UNITED STATES PATENT AND TRADEMARK OFFICE

APPLICATION NO.	FILING DATE	FIRST NAMED INVENTOR	ATTORNEY DOCKET NO.	CONFIRMATION NO.
10/709,241	04/23/2004	Ronald L. Eubanks	TKF-001	3240
26868	7590	10/28/2004	EXAMINER	
HASSE GUTTAG & NESBITT LLC 7550 CENTRAL PARK BLVD. MASON, OH 45040			HESS, DOUGLAS A	
			ART UNIT	PAPER NUMBER

Office Action Summary	Application No. 10/709,241	Applicant(s) EUBANKS ET AL. S	
	Examiner Douglas A Hess	Art Unit 3651

1. Restriction to one of the following inventions is required under 35 U.S.C. 121:
 - I. Claims 1-19, drawn to a vertical lift assembly used with a conveyor, classified in class 198, subclass 370.1.
 - II. Claim 20, drawn to a vertical lift assembly, classified in class 187, subclass 406.
2. The inventions are distinct, each from the other because of the following reasons:

FIG. 8

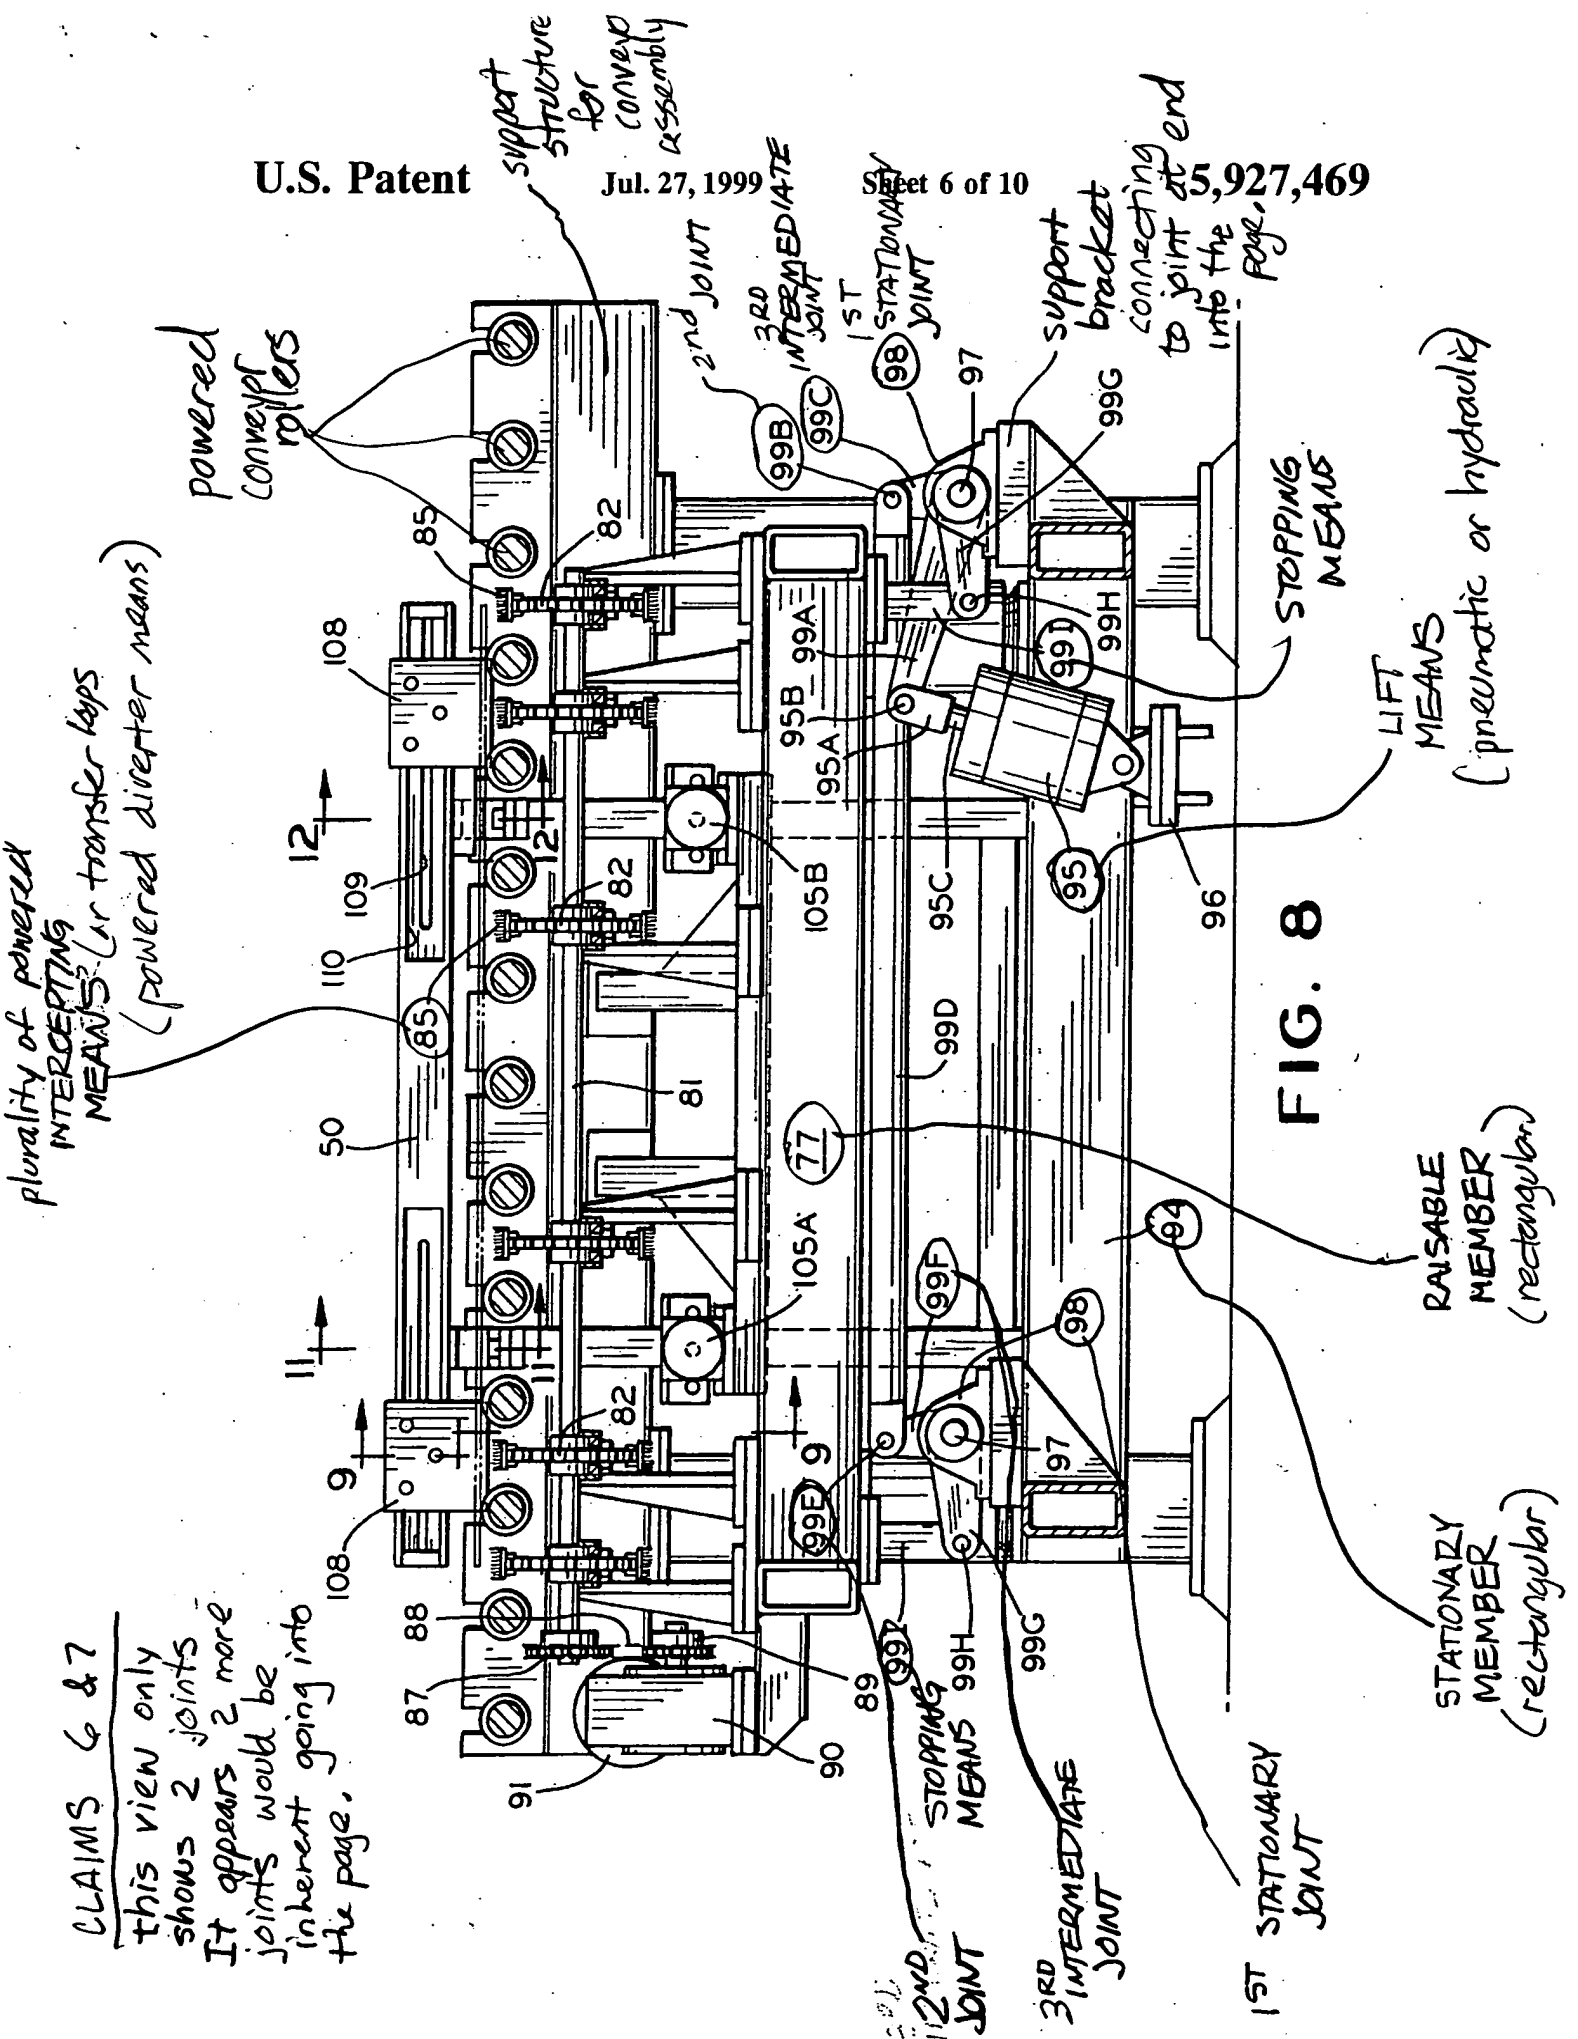
See the attached marked up drawing figures 8 and 9 of Dunifon depicting the claimed features.

CLAIMS 6 & 7

this view only shows 2 joints. It appears 2 more joints would be inherent going into the page.

plurality of powered intercepting means (or transfer levers) (powered diverter means)

support bracket connecting to joint at end into the page.

STOPPING MEANS

LIFT MEANS (pneumatic or hydraulic)

RAISABLE MEMBER (rectangular)

STATIONARY MEMBER (rectangular)
